## GFA AIRWORTHINESS DIRECTIVE

**TYPE AFFECTED:** Ventus 2c, serial numbers 1 to 76.

**SUBJECT:** CG (belly) release, installation position.

SUBJECT: C.G. release, installation position

Remark

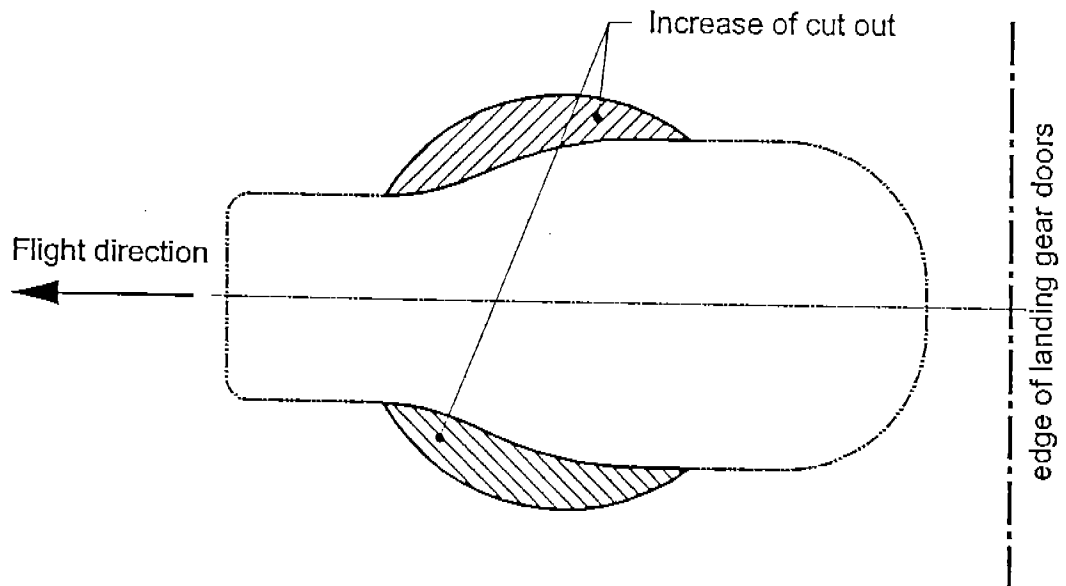
7. Modify the release cover only for  
Ventus-2c, S/N 1 through 62  
Discus-2b, S/N 1 through 55 and 57 through 64
  - a) Glue the additional release cover on top of the present cover

- b) After curing of the additional release cover abrade the inner part of the present release cover

The size of the release cover for the **countersunk** release is big enough to house the release in the modified installation position and must not be changed, see

Fuselage cut out for the not countersunk release installation

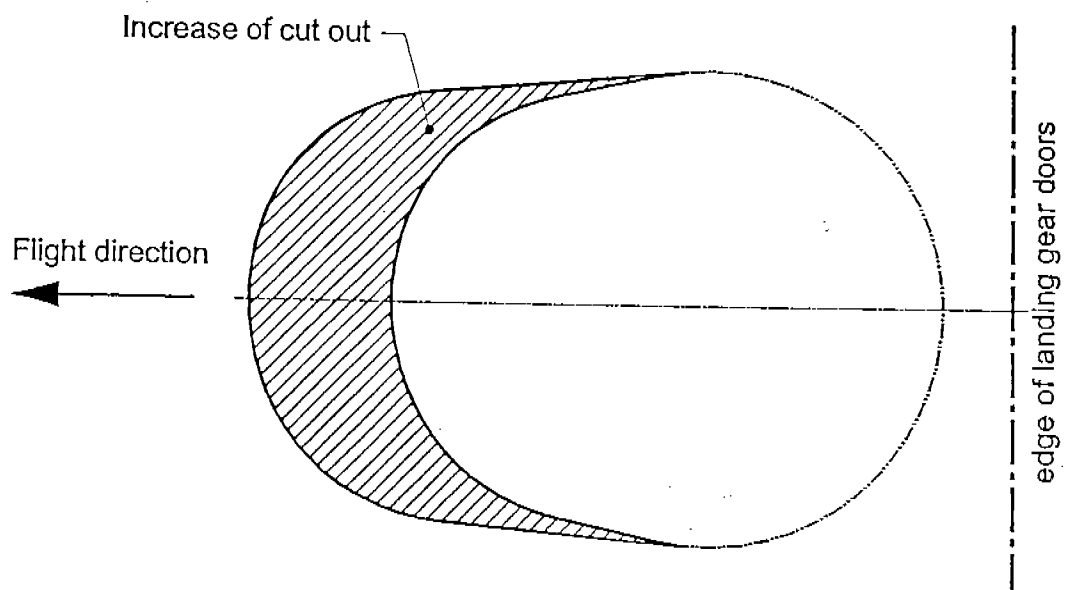
- c) Tighten again aft screw (number 5)
5. Attach cable connection with the additional fittings, see photo page 03.
6. Increase the cut out in the fuselage bottom for the release with the aid of the templates, see page 02.  
The cut out should be increased so far that with the cable ring engaged and pulled forward the pair of cable rings support against the automatic release device.

EXTRACTED FROM DRAWING  
NO. S11 RB 842

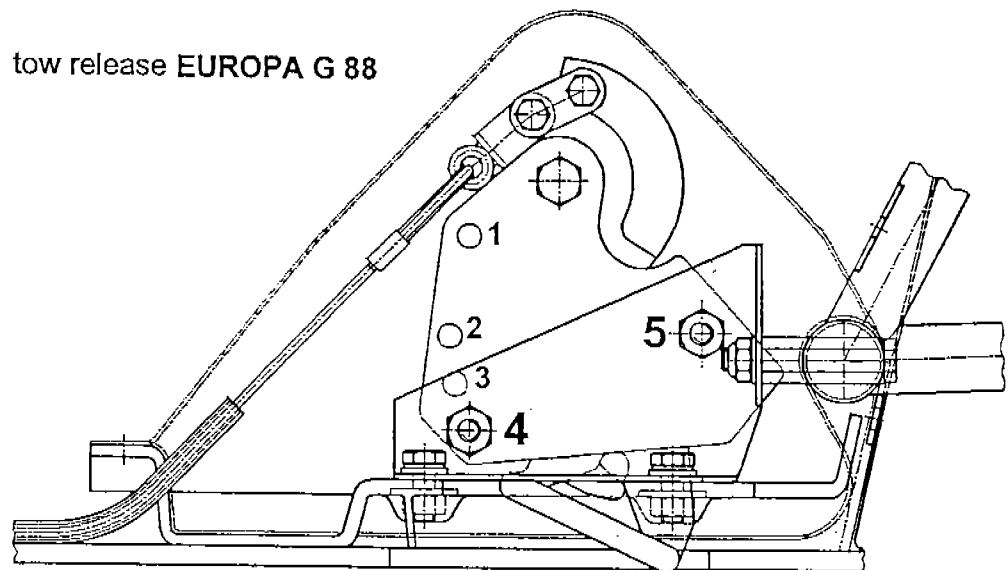
tow release EUROPA G 88

to be attached by bolts No. **4** and **5**
